# United States Patent and Trademark Office

APPLICATION NO.	FILING DATE	FIRST NAMED INVENTOR	ATTORNEY DOCKET NO.	CONFIRMATION NO.
10/645,937	08/25/2003	Denis Couillard	8238	
75	90 08/11/2006		EXAMINER	
Mr. Denis Couillard			EARLY, MICHAEL JACOBY	
71 A St. Antoine, QC	G6V 5Y5		ART UNIT	PAPER NUMBER
CANADA			3744	
			DATE MAILED: 08/11/2006	5

## **DETAILED ACTION**

FIG. 8(b)

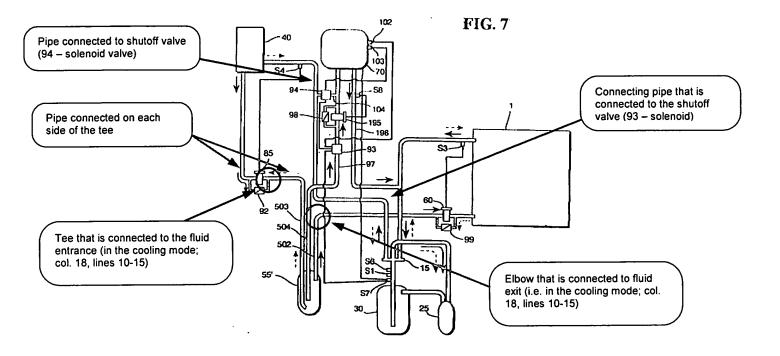
a fluid entrance (503 – tube) located in middle of the tank (55' – receiver) (as seen in the illustration of Figure 8b below) connected by a tee to a connecting pipe of each side (as seen in the illustration of Figure 7 below) and to a shutoff valve (94 – solenoid valve) connected to a pipe of the geothermal system (as seen in Figure 7);

a fluid exit (502 – tube) located in bottom of the tank (55' – receiver) (as seen in the illustration of Figure 8b below) is connected to a elbow (as seen in the illustration of Figure 7 below) connected to a connecting piece (as seen in the illustration of Figure 7 below) that is connected to a shutoff valve (93 – solenoid valve) joined to a pipe (97 – conduit section) of the geothermal system (as seen in Figure 7);
